Enclosure 3 Combined RAI Responses

ER Section 1.1

CCNPP Unit 3 Construction Water Use Diagram

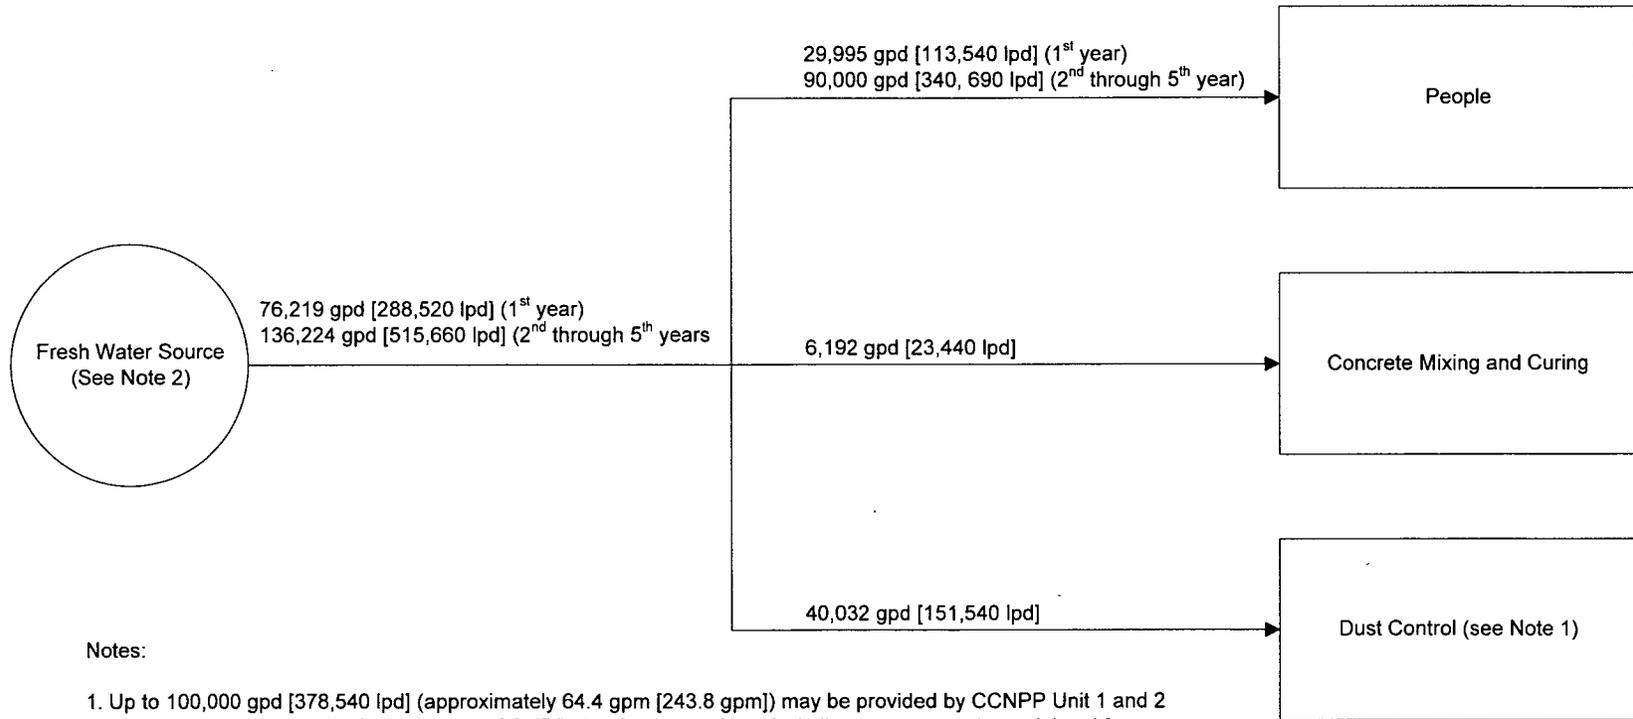
Provide a water use diagram during pre-construction and construction periods. (Cross reference with HS-7 HS-7^(a)).

A construction water use diagram has been prepared and is attached. Pre-construction water use will be similar to construction water use, but somewhat reduced, based on the prescribed level of pre-construction effort. A pre-construction schedule has not been finalized. As a result, it is not possible to provide a quantitative analysis of pre-construction water use at this time.

The construction water use diagram and a discussion of pre-construction water use will be incorporated into the ER Section 3.3 in a future revision.

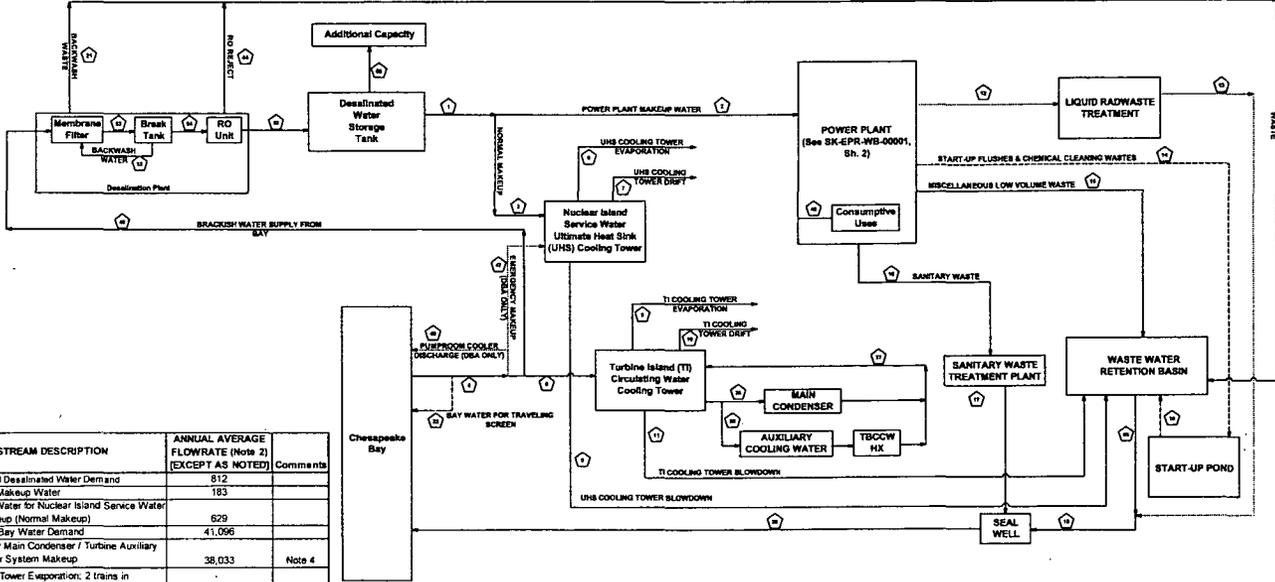
- a) Maximum Chesapeake Bay withdrawal is 43,480 gpm (97 cfs) (Table 3.3-1). Confirm that there is an error in Fig. 3.3-1, which reports 37,778 gpm.
- b) Maximum effluent discharge to Chesapeake Bay is 23,228 gpm (51.8 cfs) (Figure 3.3-1). Confirm that there is an error in Section 3.4.2.2 page 3.4-6, which conflicts with Fig 3.3-1 and Table 3.3-1. 19,437 should be 19,426; 17,366 should be 17,355, and 23,204 should be 23,228. Is 17,633 the correct value in Section 3.5.2.2 page 3.5-8?
- c) Table 3.3-1. Confirm the error in Fig 3.3-1, which reports 37,778 gpm, or provide an explanation.
- d) Page 3.3-1 notes $4.1E7$ gal/mo, which equals 935 gpm, not 3040 gpm. Confirm the error, or provide an explanation.

Provide correct values where errors are confirmed.

- 1) The value of 37,778 gpm shown on Figure 3.3-1 (Revision 0) should have been 37,788 gpm. The average withdrawal is shown in parentheses and the maximum flow of 43,480 gpm is shown below the average flow in brackets. Refer to the figure key. Both values are also listed accordingly in Table 3.3-1 (Revision 0). Note that the average and maximum flow rates for Chesapeake Bay withdrawal previously provided in the ER have been subsequently revised to 41,095 gpm and 47,383 gpm, respectively, as shown on the attached update to ER Table 3.3-1.
- 2) The values provided in Section 3.4.2.2 (page 3.4-6) for average and maximum effluent discharge and average cooling tower blowdown will be revised to agree with revisions to ER Table 3.3-1 and Figure 3.3-1.

- 3) The value of 37,778 gpm as shown on Figure 3.3-1 (Revision 0) as the anticipated average flow for bay water, should have been shown as 37,788 gpm. The average and maximum flow rates for Chesapeake Bay withdrawal previously provided in the ER have been subsequently revised to 41,095 gpm and 47,383 gpm, respectively, as shown on the attached update to ER Table 3.3-1.

- 4) In Revision 0 of the Environmental Report, the value of 4.1E7 gal/month equates to 942 gpm (i.e., 940 gpm for ESWS cooling tower evaporation plus 2 gpm for drift – see Table 3.3-1, Revision 0). This only represents a portion of the desalinated water to be used. The 3,040 gpm of desalinated water is used as follows: 276 gpm (membrane filtration) + 2,764 gpm (reverse osmosis). The value of 2,764 gpm of desalinated water is distributed as follows: 779 gpm (reverse osmosis reject) + 1,882 gpm (ESWS makeup: 940 gpm drift + 2 gpm evaporation + 940 gpm blowdown) + 103 (power plant makeup). Note that the average desalinated water consumption for the ESWS cooling towers has subsequently been revised from 4.1 E7 gal/month to 2.5 E7 gal/month, as shown on the attached update to ER Table 3.3-1. Also note that the Chesapeake Bay water demand for desalinization has been revised from 3,040 gpm to 3,063 gpm.

- 1, 3) The average and maximum flow rates from Chesapeake Bay withdrawal will be revised to 41,095 gpm and 47,383 gpm throughout the section. Table 3.3-1 and Figure 3.3-1 will also be updated.
- 2) Flows indicated in ER Section 3.4.2.2 (page 3.4-6) for the average and maximum effluent discharge to Chesapeake Bay and the average cooling tower blowdown will be revised to agree with those in the revised Table 3.3-1 and Figure 3.3-1.

- 4) Table 3.3-1 and Figure 3.3-1 will be updated.

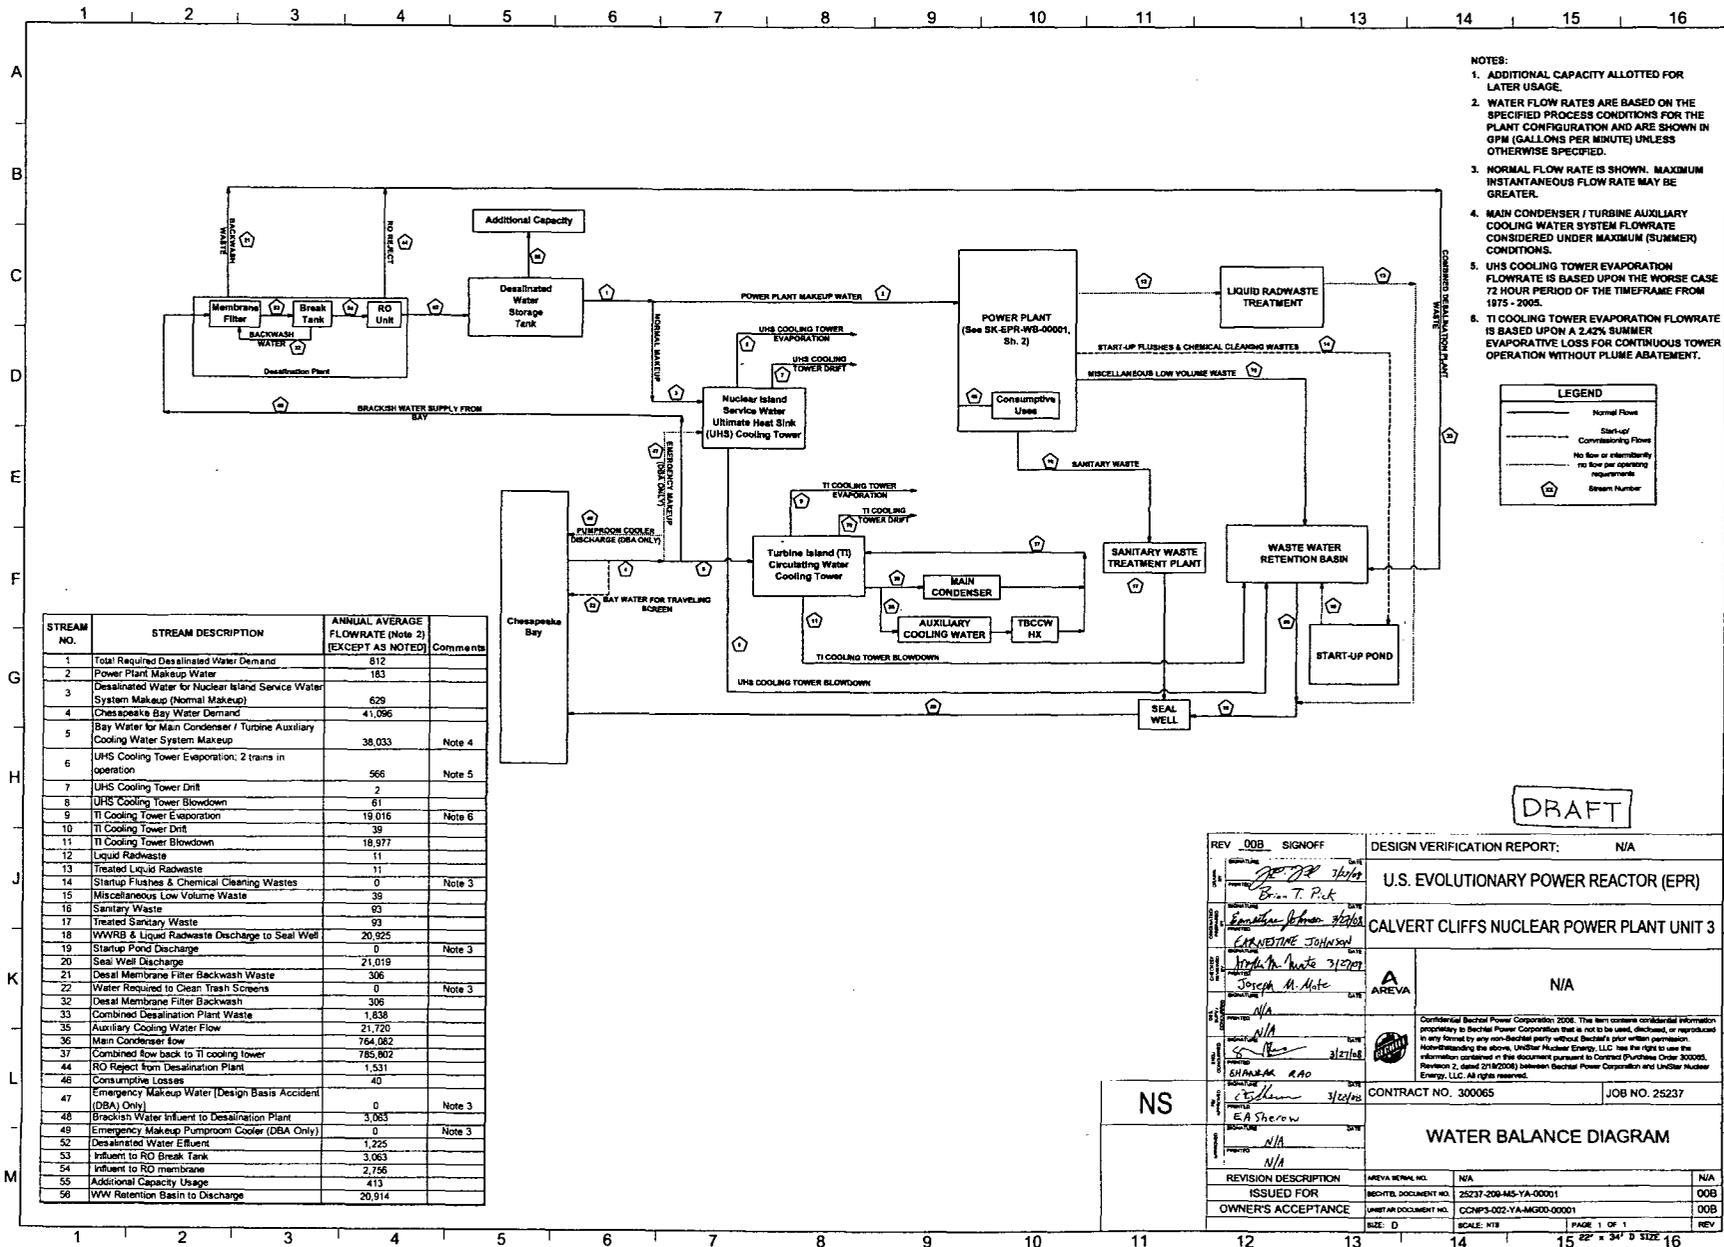
Figure 3.3-1 and Table 3.3-1 report 20 gpd from the Waste Water Treatment Plant for normal operations. Section 3.6.2 page 3.6-2 reports 19,500 gpd during construction activities. Page 3.6-2 and Table 3.6-3 suggest 19,500 gpd during normal operations. This perceived inconsistency needs to be clarified. (Cross reference with HS-34^(a))

- 1) Figure 3.3-1 and Table 3.3-1 indicate that during normal operation, treated sanitary waste will be 20 gpm, not 20 gpd. Note that 20 gpm equates to 28,800 gpd.

An updated copy ER Table 3.3-1 and a preliminary water use diagram showing updated flow values and addition of a seal well in the effluent release flow path is attached. The water use diagram will be used to update ER Figure 3.1-1, and is considered preliminary and is marked "draft" because it has not been released for construction.

For clarification purposes, treated waste water flow will be deleted from Table 3.6-3 and a note will be provided indicating that the value can be found in Table 3.3-1. Figure 3.3-1 and Table 3.3-1 will be updated to indicate the updated flow values and modified flow arrangement shown in a future ER revision.

Revised Figure 4.5-7: Dose Rate Estimated in 2015 (mrem per 8760 hours)

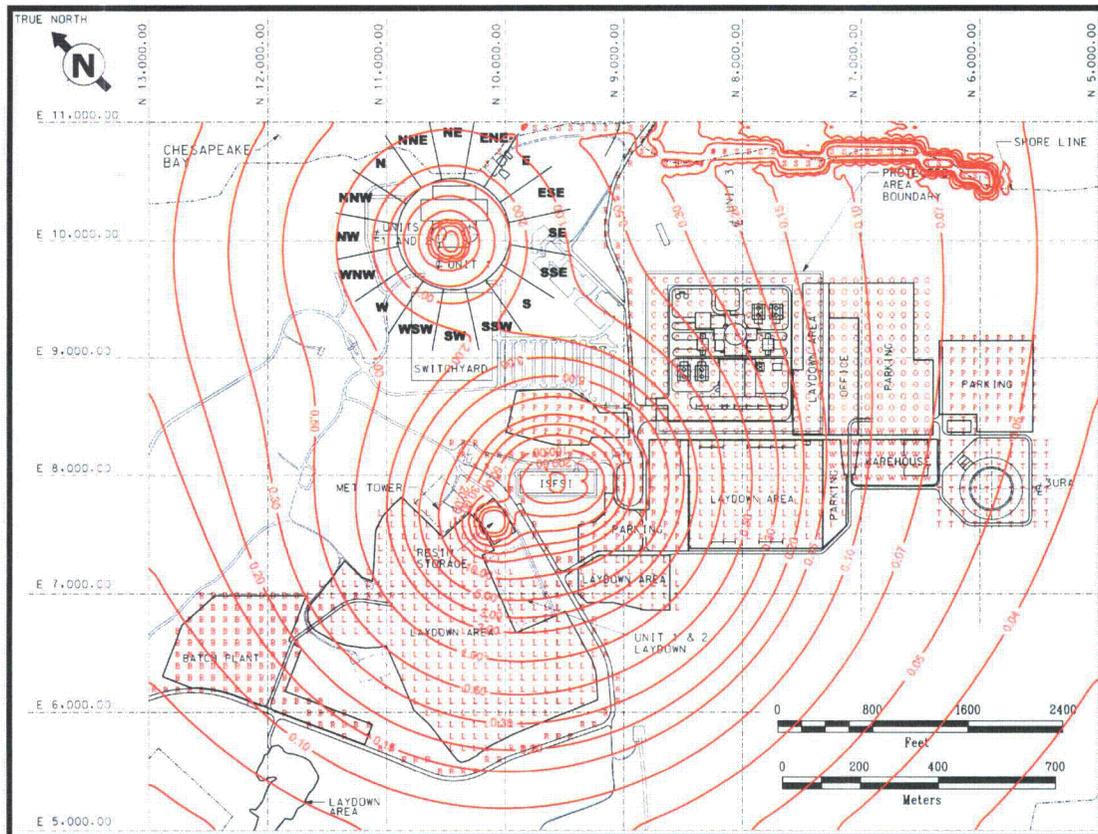
The spatial distribution of zones on the site is shown in revised ER Figure 4.5-7 (attached). The figure is annotated with red letters indicating a zone code. There are many locations where construction workers are not expected to be, so they are not marked in the Figure. Those zones that are marked were chosen because of planned activities at those locations, for example, the parking lots, roads, and the construction area.

ER Figure 4.5-7 will be revised to reflect changes in contour lines and to add a notes key to define occupational zones (updated figure attached).
